GARDEN MEADOW ADDITION

S/D 98-38 - Final Plat of GARDEN MEADOW ADDITION

S/D 98-38 - Final Plat of GARDEN MEADOW ADDITION

- CASE NUMBER:** S/D 98-38 - GARDEN MEADOW ADDITION
(formerly HENDRICK'S GARDENS)
- OWNER/APPLICANT:** John F. and Charlotte Hendrick, 12202 E. Douglas,
Wichita, KS 67206

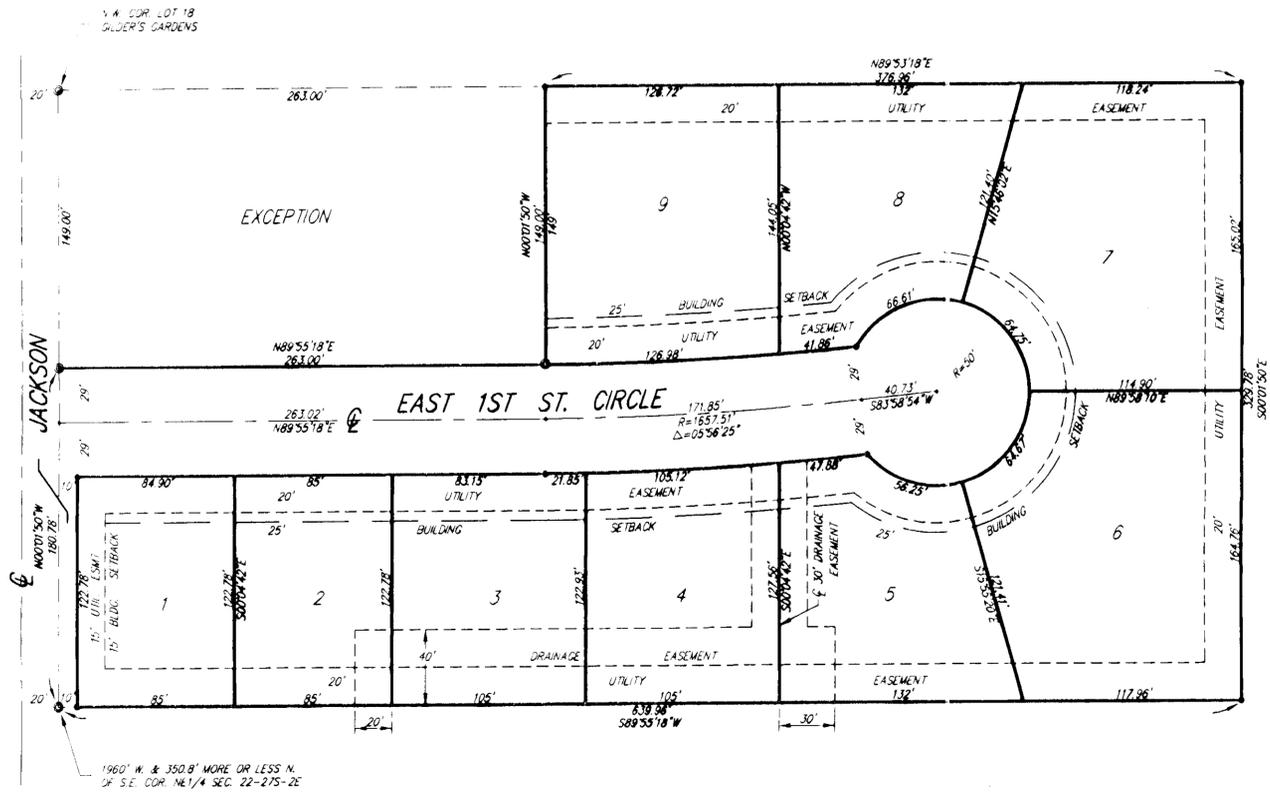
- A. City water appears to be available to this site. The applicant shall guarantee the extension of sanitary sewer to serve the lots being platted. This guarantee shall be with the County for service through the Four Mile Creek sanitary sewer system. On the final plat tracing, appropriate wording shall be added to the Mayor's signature block indicating the City's agreement to allow a County sewer district to be formed within the City. **A guarantee for City water will also be needed. A sanitary sewer layout is requested by County Engineering.**

- C. **City Engineering** needs to comment on the status of the applicant's drainage plan. **The drainage plan has been approved. An off-site drainage easement will be needed.**

- F. **Traffic Engineering** needs to comment on the need for improvements to Jackson Street. **An agreement not to protest future street improvements is requested from the applicant.**

- G. For any lots with existing tree rows that may be impacted by the installation of utilities, it is recommended that overly wide utility easements (30 foot) be platted in order to allow for the installation of the utilities without damage to such tree rows. **Sanitary sewer and KG&E services are proposed to be constructed along front yard easements and applicant prefers to maintain 20-foot rear yard easement.**

- H. **Fire Department requests that the street be renamed "E. 1st St. Circle".**
- I. On the final plat tracing, the spelling of "granted" in the owner's signature block needs to be corrected, in addition to "Hendrick".

- J. The platting binder indicates that a mortgage is being held in this site. This party shall be shown as a signatory on the final plat tracing or proof provided that the mortgage has been released.

- R. The representatives from the utility companies should be prepared to comment on the need for any additional utility easements to be platted on this property. **KG&E and Southwestern Bell request additional easements which have been denoted on the final plat.**
